# UNITED STATES PATENT AND TRADEMARK OFFICE

APPLICATION NO.	FILING DATE	FIRST NAMED INVENTOR	ATTORNEY DOCKET NO.	CONFIRMATION NO.
10/020,314	12/18/2001	Yasuhiro Shimamoto	HITA.0143	8410

**Office Action Summary**

**DETAILED ACTION*****New Grounds of Rejection******Claim Rejections - 35 USC § 102***

**Fig. 8**

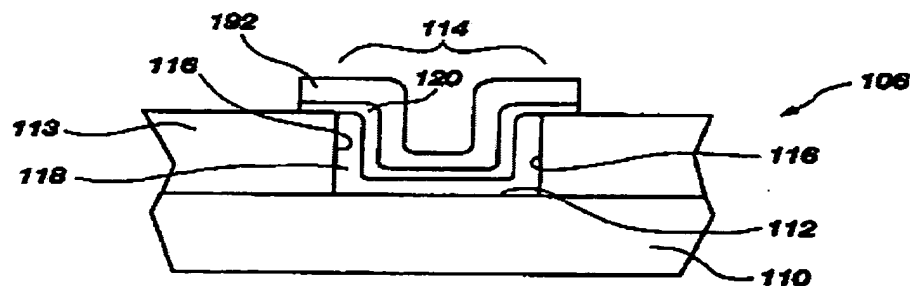
In re claim 1, Marsh discloses a fabricating method of a semiconductor integrated circuit device 106 comprising forming a bottom electrode 118 (col. 10, lines 39-62) of a capacitor with high-k material on a semiconductor substrate 110 by a chemical vapor deposition method in a sub-atmospheric pressure using an organoruthenium compound as a precursor (col. 7, lines 50-67 and FIG. 8), which includes steps of:

providing the semiconductor substrate 110 in a deposition chamber;

increasing a temperature of the semiconductor substrate 110 in the chamber up to a desired temperature (col. 7, lines 50-60);

separately supplying the precursor and an oxidation gas into the deposition chamber to form a ruthenium film for the bottom electrode with a desired thickness on the heated semiconductor substrate, the oxidation gas being separately supplied to the deposition chamber by a supplying system different from a precursor supplying system and only during when the precursor being supplied (col. 7, line 50 to col. 8, line 61); and

stopping the supply of the precursor and the oxidation gas and decreasing the temperature of the semiconductor substrate, wherein the bottom electrode essentially consists of ruthenium (col. 8, lines 23-46).

**Fig. 8**

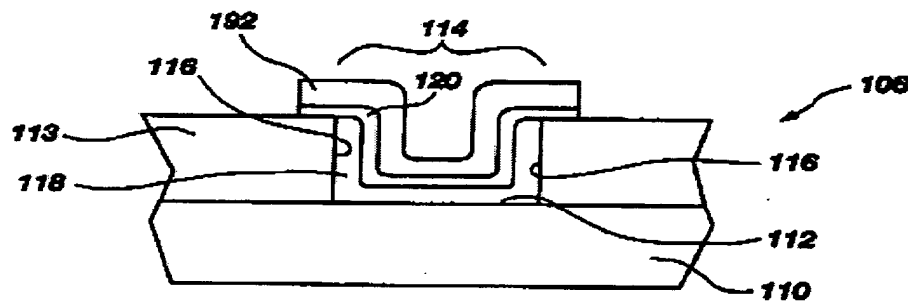
In re claim 21, Marsh discloses a fabricating method of a semiconductor integrated circuit device 106 comprising forming a top electrode 192 (col. 10, lines 39-62) of a capacitor with high-k material on a semiconductor substrate 110 by a chemical vapor deposition method in a sub-atmospheric pressure using an organoruthenium compound as a precursor (col. 7, lines 50-67 and FIG. 8), which includes steps of:

providing the semiconductor substrate 110 in a deposition chamber;

increasing a temperature of the semiconductor substrate 110 in the chamber up to a desired temperature (col. 7, lines 50-60);

separately supplying the precursor and an oxidation gas into the deposition chamber to form a ruthenium film for the top electrode with a desired thickness on the heated semiconductor substrate, the oxidation gas being separately supplied to the deposition chamber by a supplying system different from a precursor supplying system (col. 7, line 50 to col. 8, line 61); and

stopping the supply of the precursor and the oxidation gas; and decreasing the temperature of the semiconductor substrate, wherein the top electrode essentially consists of ruthenium (col. 8, lines 23-46), and the oxidation gas is supplied to the deposition chamber when the substrate temperature is increased, when the precursor is supplied, and when the substrate temperature is decreased (col. 7, line 62 to col. 8, line 40).
